**Town of Nags Head Planning Board
Nags Head Municipal Complex Board Room
Tuesday, June 18, 2024; 9:00 a.m.**

Subject: Site Plan Amendment for Inn at Whalebone, 87-unit Hotel located at 6632 W. Pheasant Avenue (W. Lakeside Street).

At this time, the applicant is requesting that consideration be given to various Site Plan amendments as well as a request to eliminate in whole, or modify, the requirements imposed by Condition #1 as it relates to the widening of Lakeside Street.

TRAFFIC IMPROVEMENTS FOR W. LAKESIDE ST.

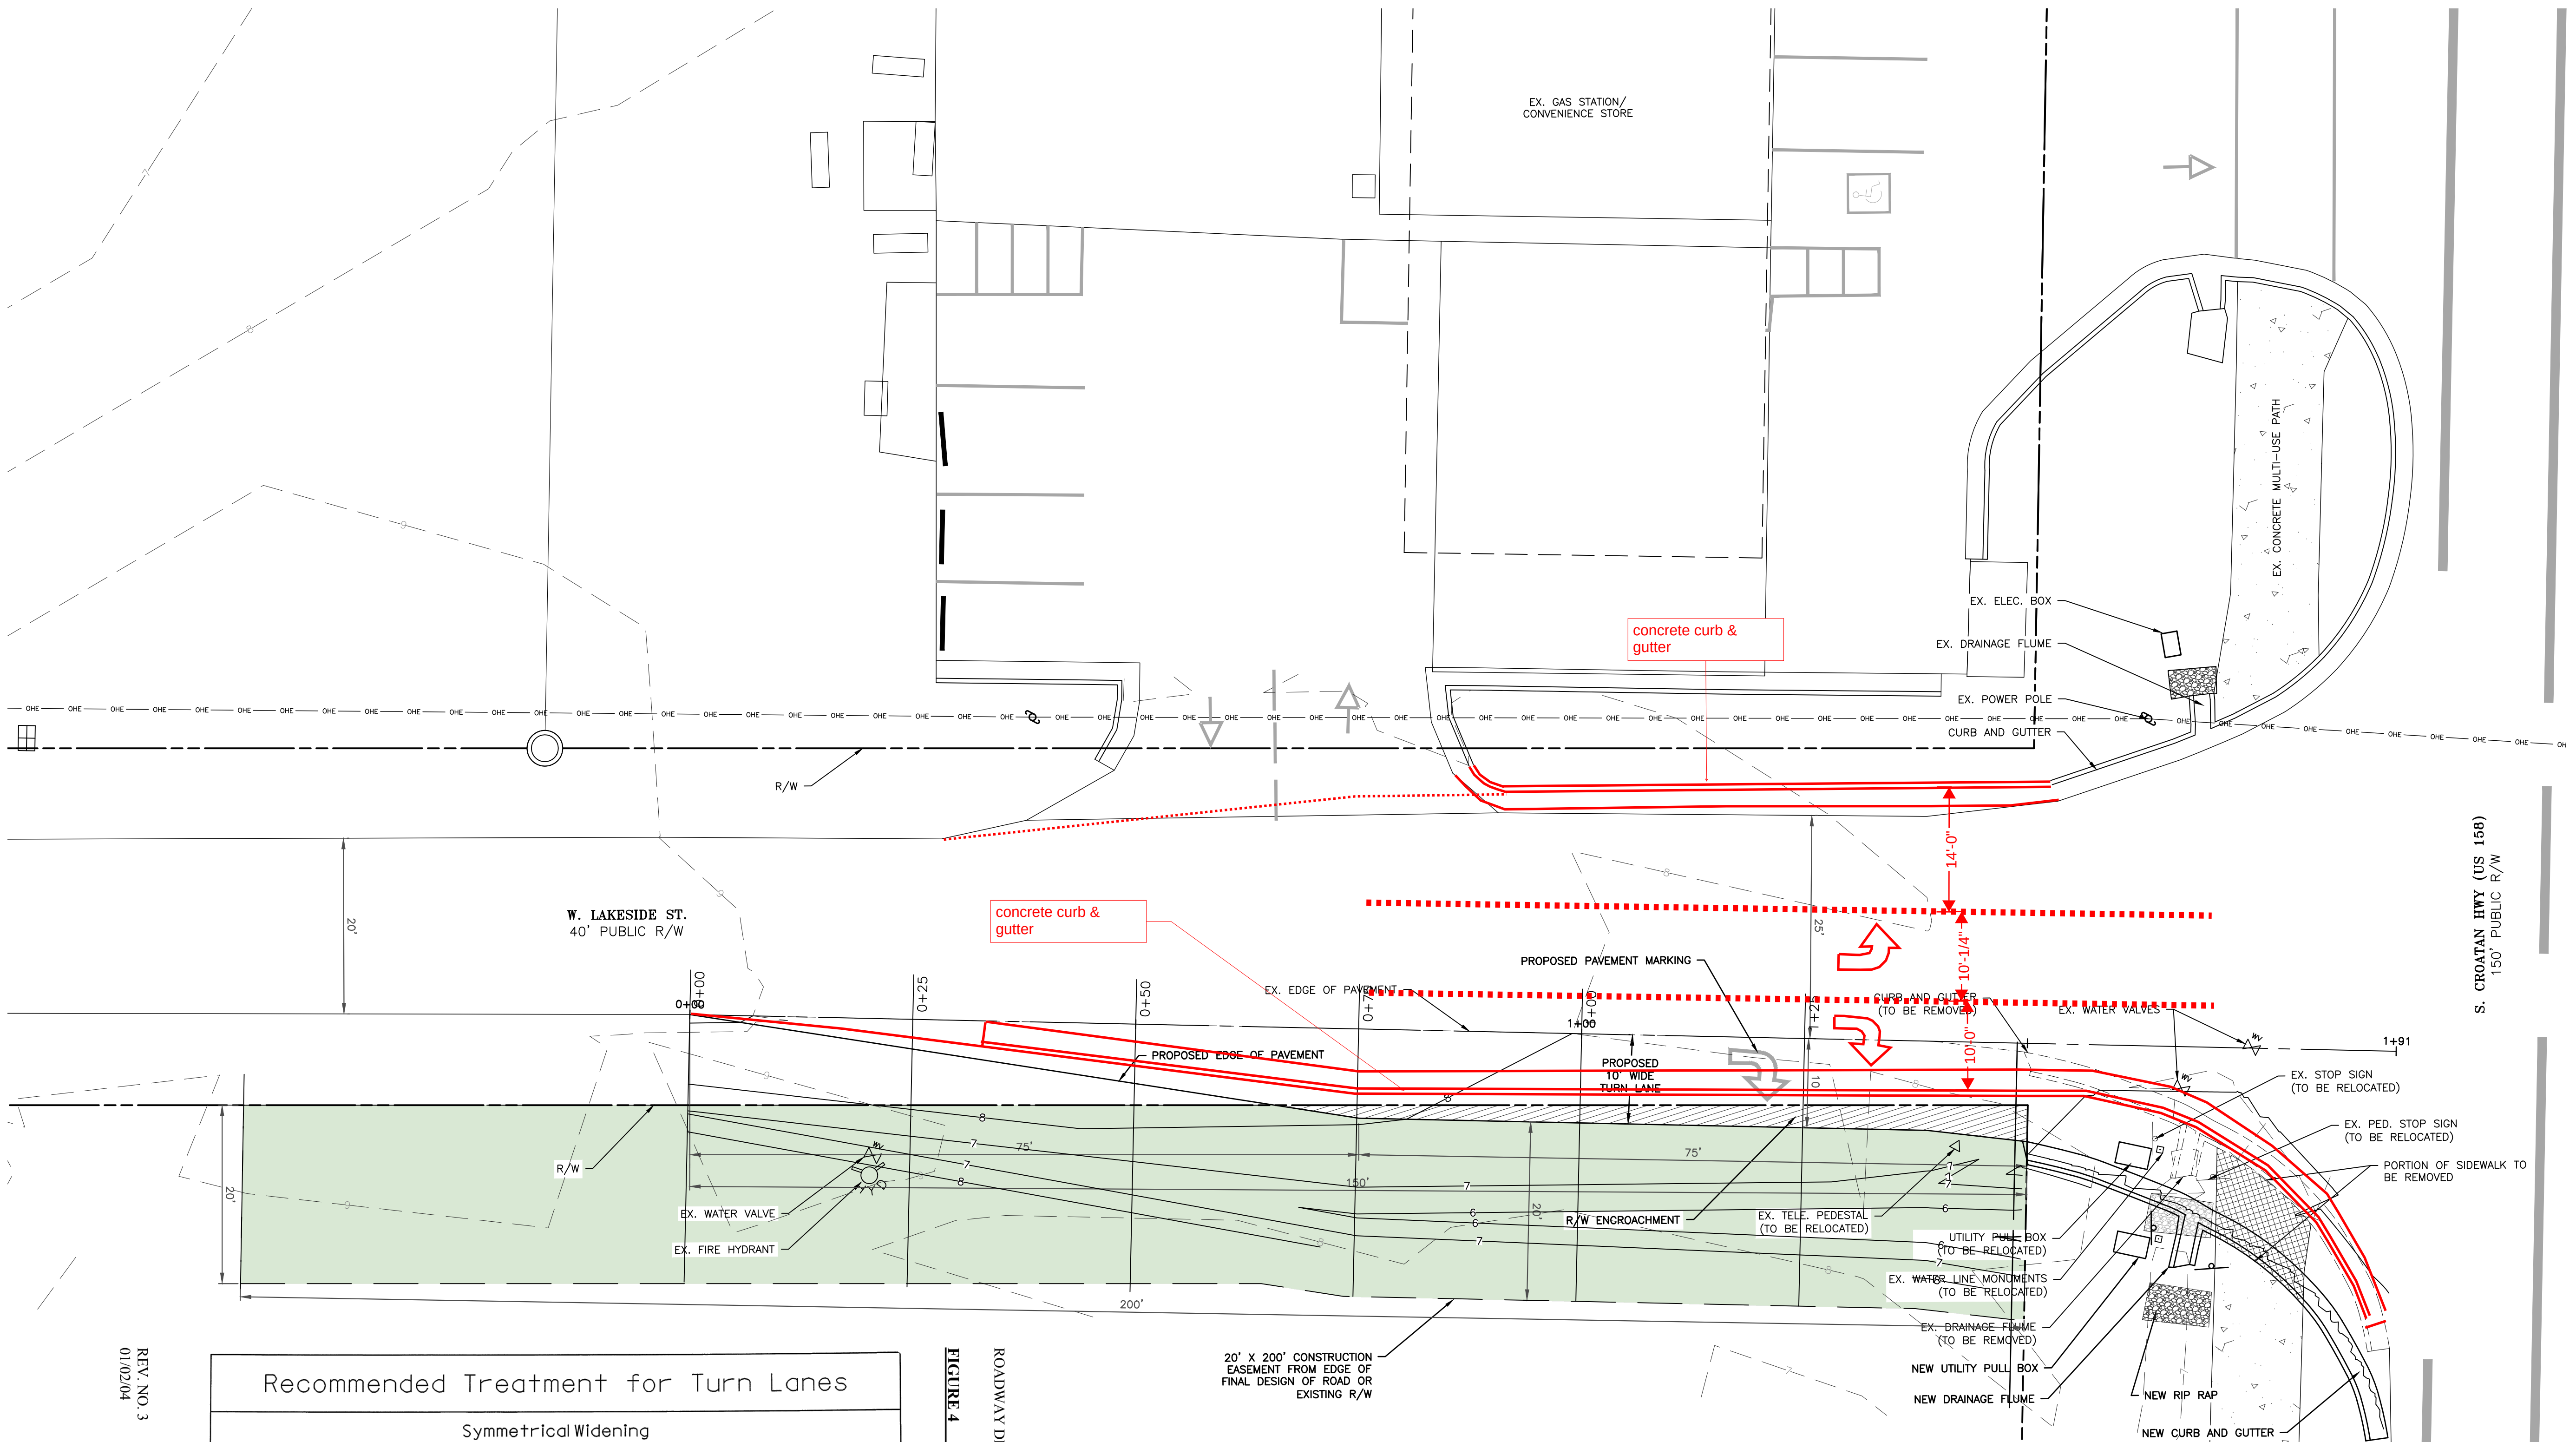
“Lakeside Street Turn Lane Exhibit- A condition was placed on the previous site plan approval to widen the Lakeside St roadway extending from S. Croatan Hwy. to the westernmost boundary of the subject property. With the existing Lakeside St. right-of-way width at 40’ there are some impacts associated with a roadway widening of this length. These impacts include runoff onto adjoining properties and potential conflicts with above ground utilities. However, there is still an opportunity to provide roadway widening to meet the intent of the previous Board of Commissioners conditioned approval.

The applicant has submitted an exhibit which shows a reduced widening plan from the eastern property boundary. This concept indicates an encroachment onto the adjoining undeveloped property to the south. Attached is an exhibit mark-up which describes a potential alternative roadway widening approach which may not result in improvements extending onto private property. The recommendation is for the applicant to modify the traffic improvements for Lakeside St. to reflect the approach as identified in the attached plan mark-up. This approval would be conditioned on the applicant acquiring detailed survey information for the development of a roadway widening and construction plan in accordance with Chapter 36-4 of the Town Code of Ordinances. It should be noted that a temporary construction easement may be required from the owner of the undeveloped property to the south for the purposes of construction in addition to a right-of-way encroachment through NCDOT.”

Regarding the applicant's request to remove or modify the condition to widen Lakeside Street, this condition was included in the October 4, 2023, Board of Commissioners (BOC) approval to address traffic concerns raised by citizens and Board members. While fully meeting this condition could impact runoff onto adjacent properties and conflict with above-ground utilities, there is an opportunity to widen a portion of the roadway. This approach would fulfill the intent of the Board of Commissioners' conditioned approval without encroaching on adjoining properties. Staff recommends that the Planning Board recommend modifying the previous BOC approval to reflect the alternative roadway design proposed by the Town Engineer.
